## Bike Winnipeg Precinct K Suggestions

Submitted March 14, 2014

**Bike Winnipeg AT Corridor Additions**

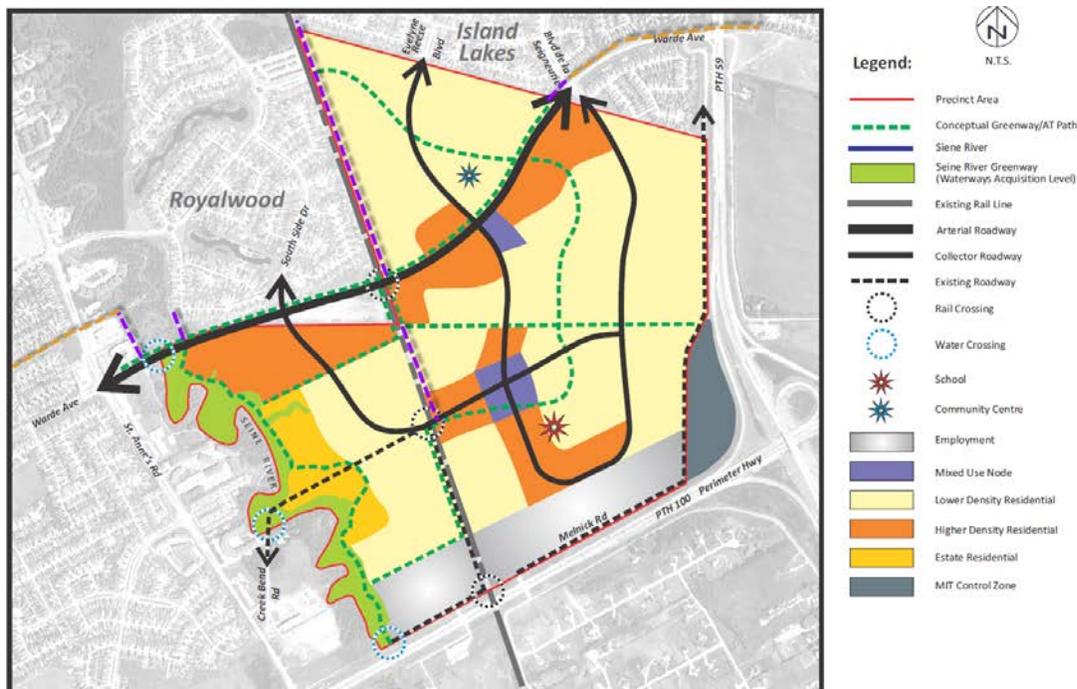
Additions being suggested by Bike Winnipeg are shown in violet dashed lines below.

The AT Corridor currently identified along the east side of CPR line should be extended to the north and south along the east side of the tracks to extend from the southern rail crossing of Creek Bend Road through to northern end of the precinct, with the goal of connecting into Ebb Tide Drive. This would require negotiation with CPR to allow an easement to connect to Ebb Tide Drive.

The proposed AT network should include the link between the Warde AT Corridor and the South St. Vital Trail to the north.

By connecting into the southwest corner of Bridgetown Drive, the precincts AT network would provide a low stress connection into the Bois-des-esprits Trail and the Louise Riel Sr. Trail.
